The following modifications now apply to standard 6-cylinder engines starting October 1971:

Standard Installation of Modified Versions a - e

Fig. 01-11/2

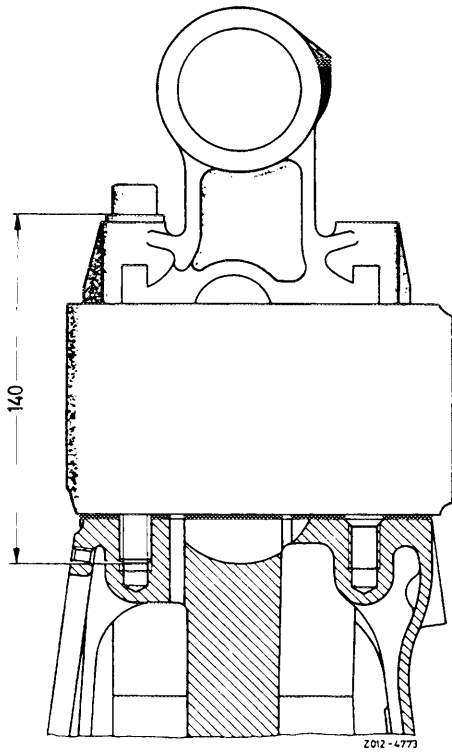
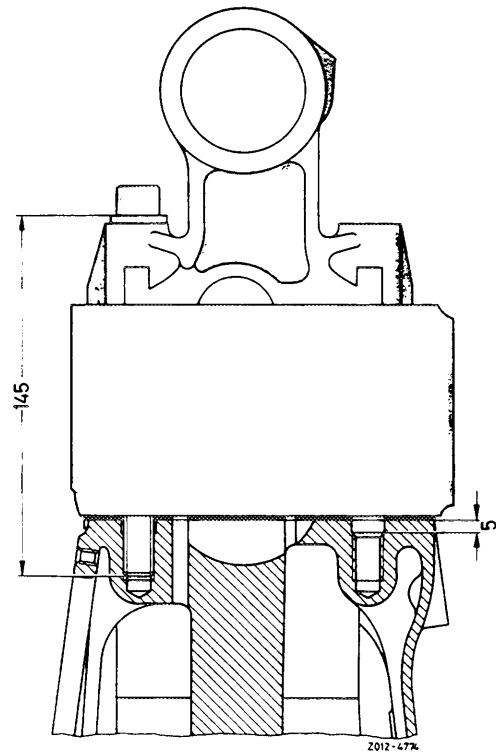
These tapped holes are countersunk for 5 mm at cylinder crankcase and are drilled that much deeper. Therefore, cylinder head bolts are now 115 and 145 mm long (formerly 110 and 140 mm) (Fig. 01-11/2).

Caution! Cylinder head bolts M 12 x 140 and M 12 x 110 may no longer be used for the modified cylinder crankcase, because threads may be torn out. Vice versa, cylinder head bolts M 12 x 145 and M 12 x 115 may not be screwed into cylinder crankcase of version used up to now, because they will be stuck at bottom of hole.

Fig. 01-11/3

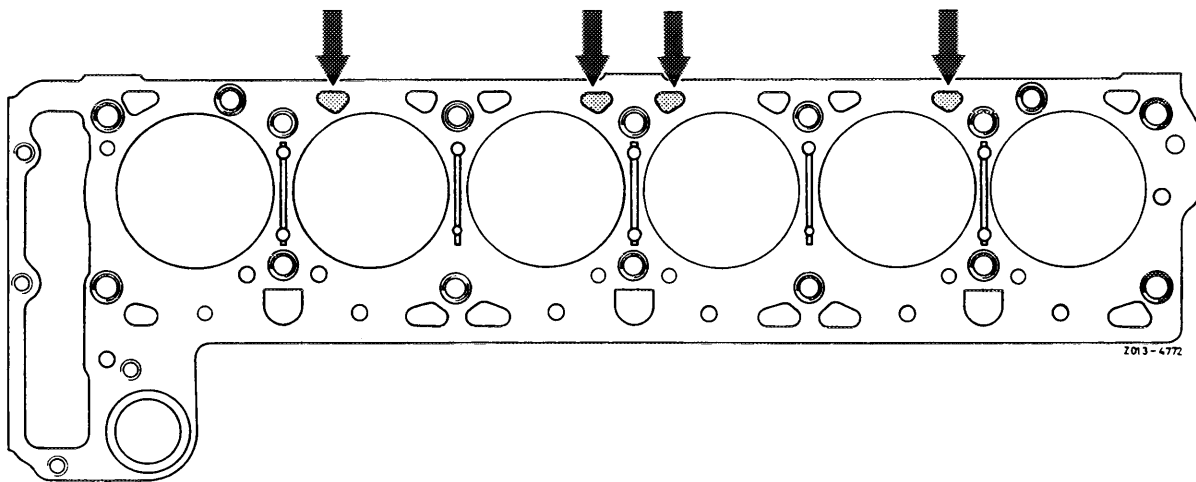
The cylinder crankcase has been provided with four additional kidney-shaped cooling water holes (Fig. 01-11/3).

Fig. 01-11/4

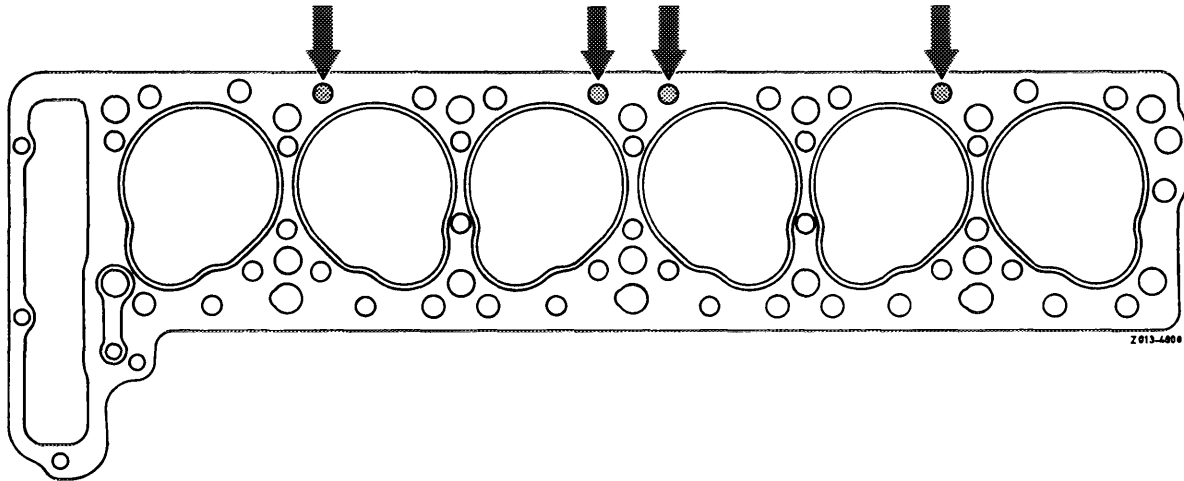
In accordance with these cooling water holes, a modified cylinder head gasket with four additional

round holes will be used (Fig. 01-11/4).

Fig. 01-11/5

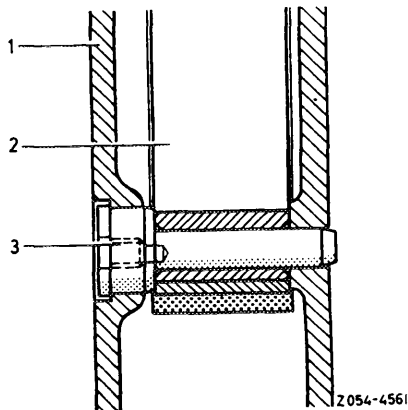
These vehicles were provided with the slide rail bearing bolt which is already used as a tensioning rail bearing bolt on four-cylinder models.

Caution! Be sure to coat sealing surfaces of bearing bolts with Hylomar sealing compound during installation. For pulling-out bearing bolt, use impact puller 116 589 20 33 00 (basic unit) and threaded

bolts M 6, 116 589 02 34 00, or threaded bolts M 8, 116 589 03 34 00.

Fig. 01-11/7

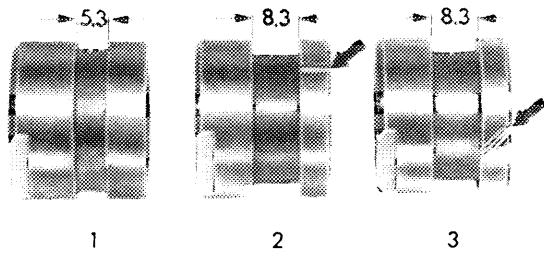
The oil groove at front bearing bushing of intermediate gear shaft has been increased and a notch has been applied (arrow in Fig. 01-11/7).

Caution! This bearing bushing can be installed in modified crankcase only.

Fig. 01-11/8

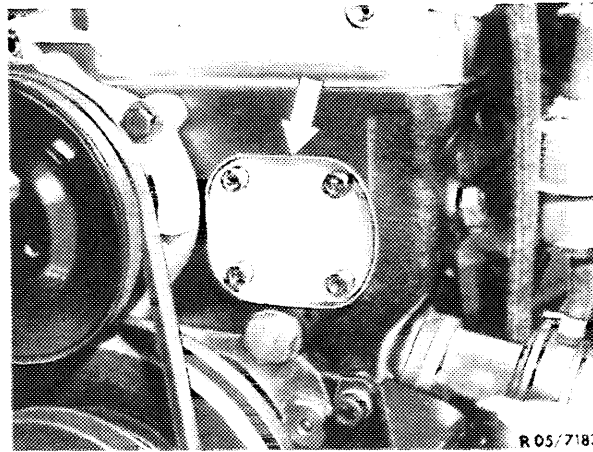
Fastening bolts and tapped holes in cylinder crankcase were changed from M 6 x 12 to M 8 x 12 (Fig. 01-11/8).

Accordingly, the closing cover on cylinder crankcase and the pertinent gasket were also changed.

Caution! The modified closing cover and the pertinent gasket may be used only on engines with tapped holes M 8. On engines with tapped holes M 6, use former closing cover with pertinent gasket. Both parts will continue to be available as a spare part.
